# Carvana JSP 18-47

Public hearing at the request of Carvana for JSP 18-47 Carvana Novi for Planning Commission's approval of the Special Land Use, Preliminary Site Plan and Storm Water Management plan. The applicant is proposing a 5,800 square foot Vending Machine Fulfillment Center to building to facilitate storage and sales for used cars. The site plan proposes approximately 26 parking spaces including four spaces for single car hauler trucks.

# PLAN REVIEW CENTER REPORT

**Review Date:** November 19, 2018  
**Review Type:** Preliminary Site Plan with SLU: 1<sup>st</sup> Revision  
**Project Name:** **18-47 CARVANA**  
**Plan Date:** October 26, 2018  
**Prepared by:** Sri Ravali Komaragiri, Planner  
**E-mail:** [skomaragiri@cityofnovi.org](mailto:skomaragiri@cityofnovi.org) **Phone:** 248.735.5607

ORIGINAL ISSUE:  
 9/5/2018  
 KHA PROJECT NO.  
 190014003  
 SHEET NUMBER  
**C1.0**

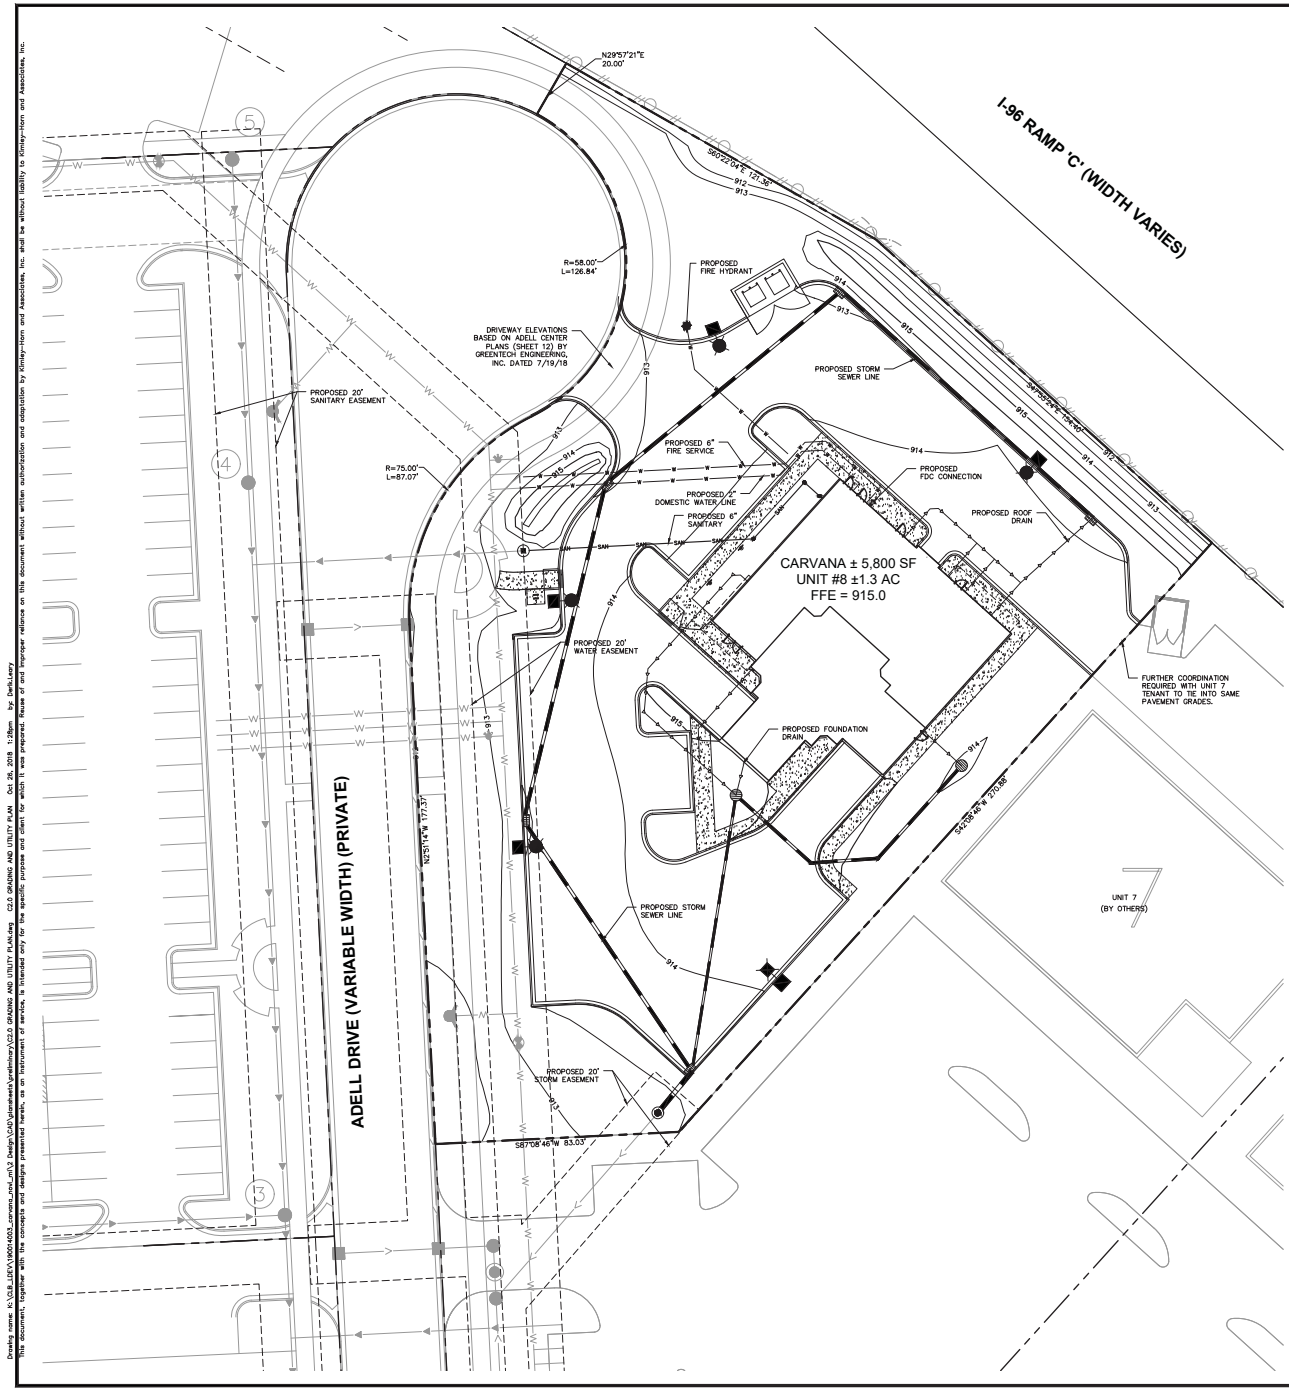
| Item   | Required Code  | Proposed   | Meets Code | Comments   |
|--|--|--|------------|--|
| <b>Required Parking Calculation</b><br>(Sec. 5.2.12)<br>(Sec. 4.82.2)  | Proposed use is not listed in Section 5.2. Minimum required parking is to be determined based on parking study   | Proposed: 26 spaces<br>4 single car hauler spaces  | Yes?       | Based on study, 20-22 minimum parking spaces may be allowed if additional information requested in parking study review is provided.<br><br><b>Please update the numbers on site plan. It indicates 30 proposed spaces. Only 26 are provided</b> |

| Item   | Required Code  | Proposed   | Meets Code | Comments  |
|--|--|--|------------|---|
| <b>Bicycle Parking Lot layout</b><br><i>(Sec 5.16.6)</i>   | Parking space width: 6 ft.<br>One tier width: 10 ft.<br>Two tier width: 16 ft.<br>Maneuvering lane   | Not indicated  | No         | <b>Please provide the required layout</b>   |

| Item   | Required Code  | Proposed  | Meets Code  | Comments   |
|--|--|---|-------------|--|
| <b>Loading Space Area (Sec. 5.4.2)</b><br><br>In the ratio of 10 sq. ft. per front foot of building. | 750 SF is requested as part of the Adell Center PRO  | It appears to be 750 SF   | <b>Yes?</b> | <b>Indicate the loading zone area on the plans.</b>                |

| Item  | Required Code   | Proposed   | Meets Code | Comments   |
|---|---|--|------------|--|
| <b>Accessory Structures (Sec. 4.19)</b>                                       | - Each accessory building shall meet all setback requirements for the zoning district in which the property is situated<br>- Shall meet the façade ordinance standards  | Accessory structures are not proposed                      | NA         | <b>A transformer detail is provided on sheet L2.1. A location is not shown on the layout. Please indicate the location of transformer on plans</b> |

**BUILDING ELEVATIONS**

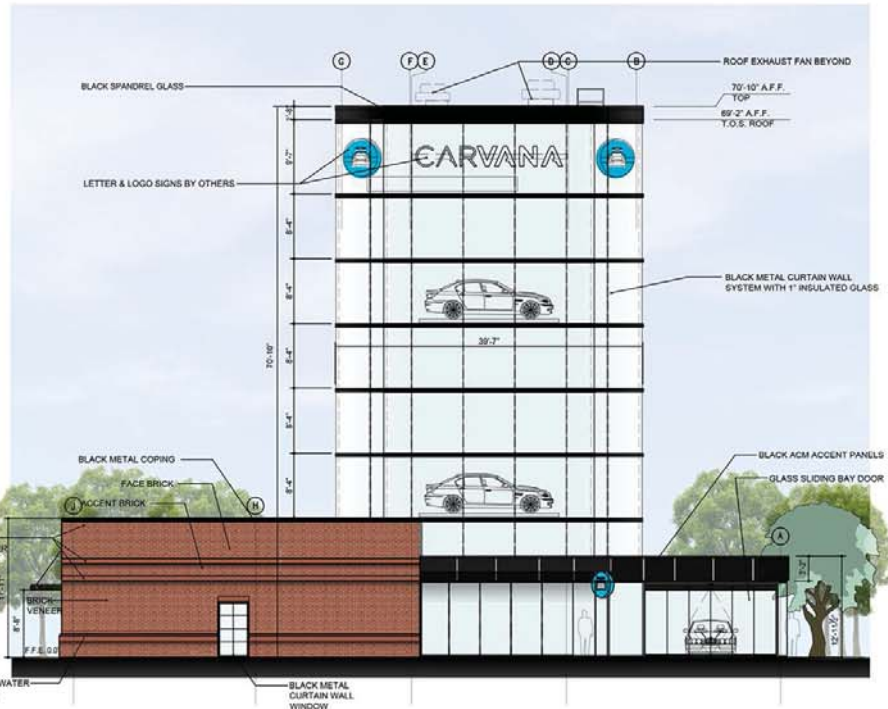
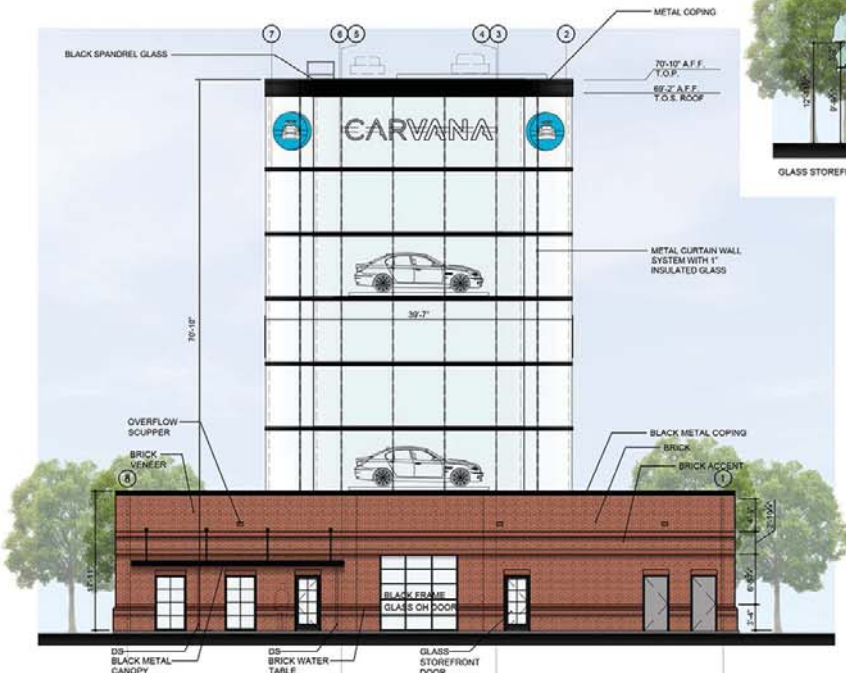
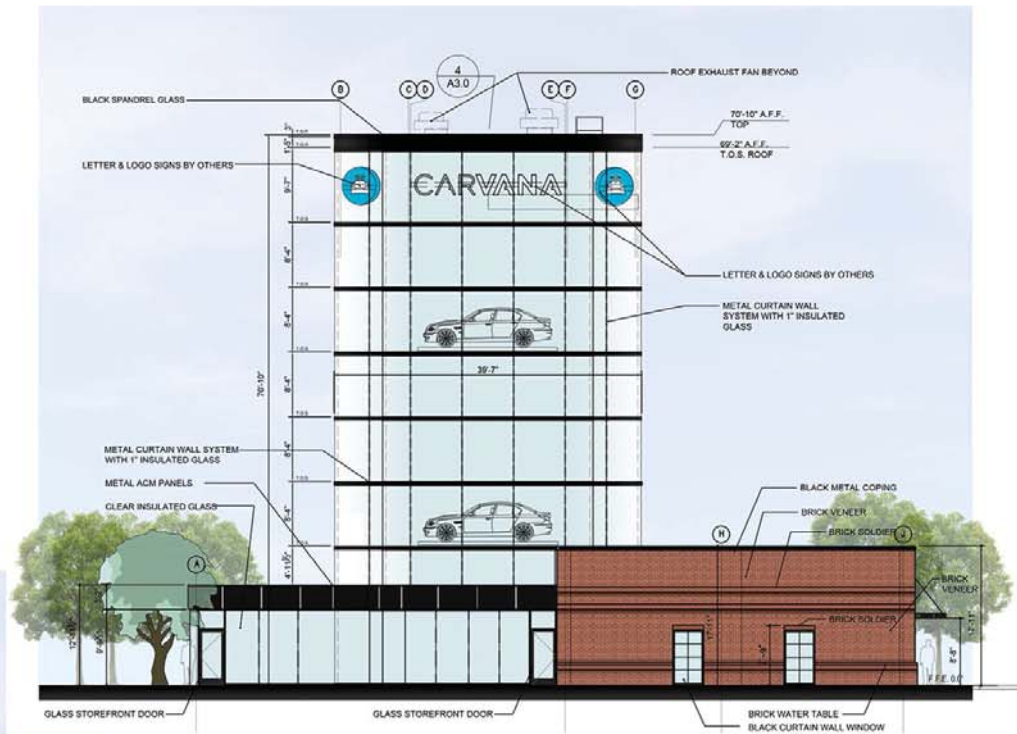
| Item   | Required Code  | Proposed   | Meets Code | Comments  |
|--|--|--|------------|---|
| <b>Building Height</b><br>(Sec.3.1.26.D)                                     | 5 stories or 65 ft, whichever is less<br><br>Provisions for additional height only applies for TC-1, not TC district<br><br><b><u>Buildings in excess of 55' may need to conform to the 2015 International Building Code standards for High-Rise (Type I or Type II) construction.</u></b> | Unit 8: 70'-10" and 8 tiers (Carvana)  | Yes        | <i>This deviation is currently being considered as past the Adell Center PRO request.</i><br><br>The deviation request refers to 75'-10" Plans indicate 70-10". Additional height is less than the deviation granted. |
